ARLINGTON COUNTY, VIRGINIA

**County Board Agenda Item
Meeting of December 15, 2007**

SUBJECT: Park Master Plan for Herndon & 13th Park located along 13th Street between N. Hartford and N. Herndon Streets.

Herndon & 13th Street Park Master Plan

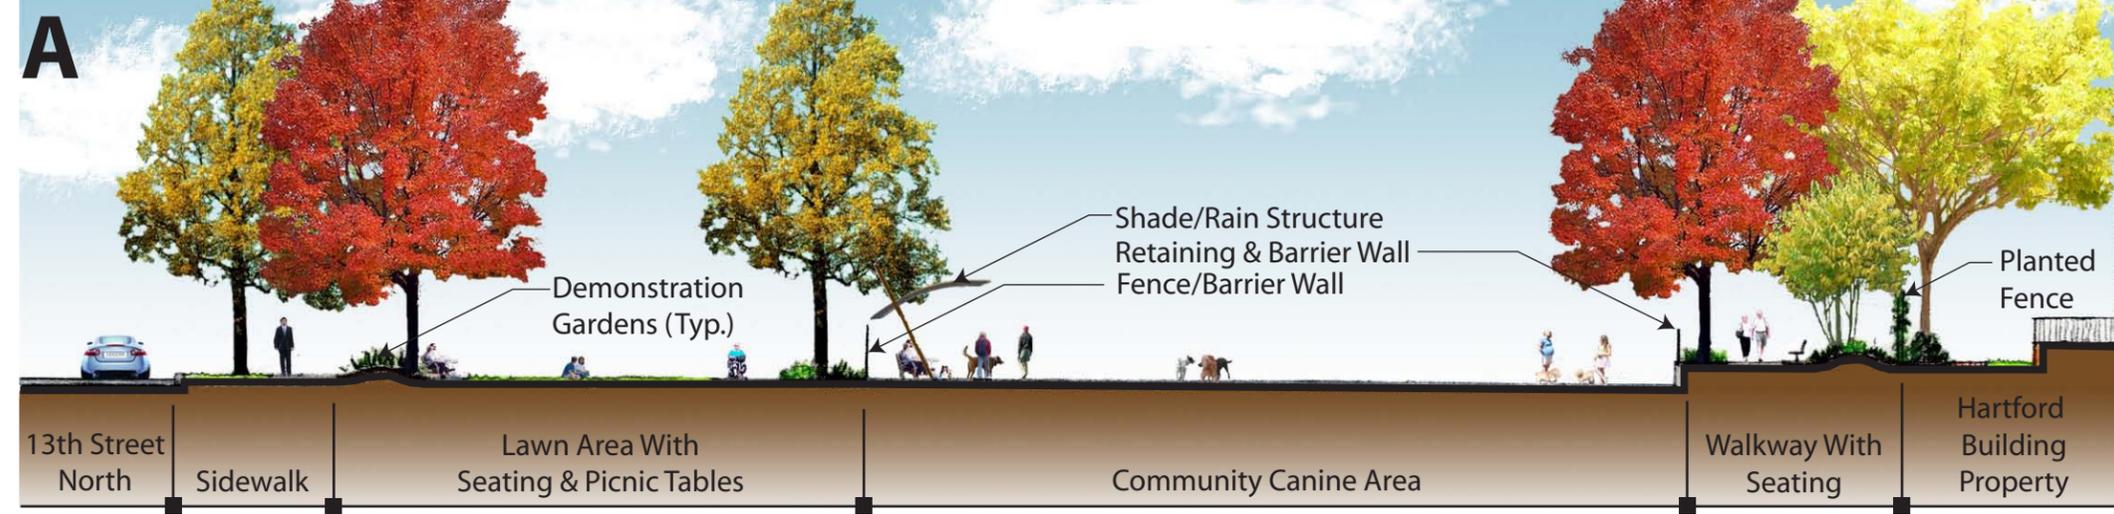
- 1) **Provide for additional open green space and seating area on the northwest corner of the park** - In response to an interest expressed by members of the Lyon Village Civic Association at our meeting that additional lawn area and seating areas to be provided on the 13th and North Hartford street corner of the park, the Commission recommends that staff reposition, reconfigure and/or truncate the northwest corner of the proposed community canine area in the final park design. While we support trying to accommodate the Lyon Village Civic Association's interest in providing additional lawn area and park seating on the northwest park corner, it is our recommendation that that the proposed size of the canine community area (CCA) in the park not be reduced by any more than 1500 square

feet from the 15,500 CCA area contained in the plan as presented to the Commission by County staff. We have concerns that a CCA area that is less than 14,000 square feet will not adequately meet the expected CCA demand and usage given that this is the only CCA located in the Rosslyn-Ballston corridor and serving the Lyon Village Community, both areas where there are a considerable number of dog owners. If the County staff is able to reconfigure the CCA to achieve additional passive parkland space as requested by the Lyon Village Community with out reducing the size of the CCA, that too would be acceptable to the Commission.

- 2) **Relocate CCA entrances** - In the final design of the park, we would encourage the staff to reconfigure the entrances to the CCA area such that they come directly off from N. Herndon and N. Hartford streets. Currently, the plan calls for an entrance to the CCA off of N. 13th street. We feel that repositioning this entrance to N. Harford Street can help to accommodate the interest expressed to the Commission for more lawn area on the northwest corner of the park.

- 3) **Maintain tree canopy and relocate some trees and shrubs currently planned outside of the fenced CCA area to within this area** – The Commission would urge that there be no net reduction in the planned number of trees and shrubs for the park. To accommodate the interest expressed by the Lyon Village Civic Association for providing additional lawn area surrounding the CCA, we would urge that staff consider placing trees and shrubs currently planned to be located outside of the CCA to be relocated inside and along the edges of the CCA area. This will help to provide more lawn area surrounding the CCA area while still maintaining buffers and square footage inside the CCA. The Commission would also strongly recommend that a few trees be added to the center of the CCA that will eventually grow to a size that will provide a significant tree canopy and shade within the CCA itself.

There has been some discussion of reallocating space between the CCA and other uses. Whether or not such changes are made, the Urban Forestry Commission strongly recommends that there should be no reduction in the number of trees planted. It is important to take advantage of any opportunity to increase tree canopy in Clarendon.

The preliminary plan does not show any trees in the CCA, and we understand that surface materials being considered for that area would not provide a healthy environment for tree roots. Perhaps some trees could be planted inside the perimeter of the CCA, with soil for their roots and protection against soil compaction. We suggest that this option be considered in the design phase as the design plan is being prepared.

Finally, we note that the preliminary master plan calls for two sidewalks within the boundaries of the park. Reducing impervious surface in the park would provide a better

environment for the roots of nearby trees and also reduce stormwater runoff. The Urban Forestry Commission urges that options for reducing the amount of impervious surface in the park be examined in the design phase.

The exact location will be addressed during the design phase for this project.
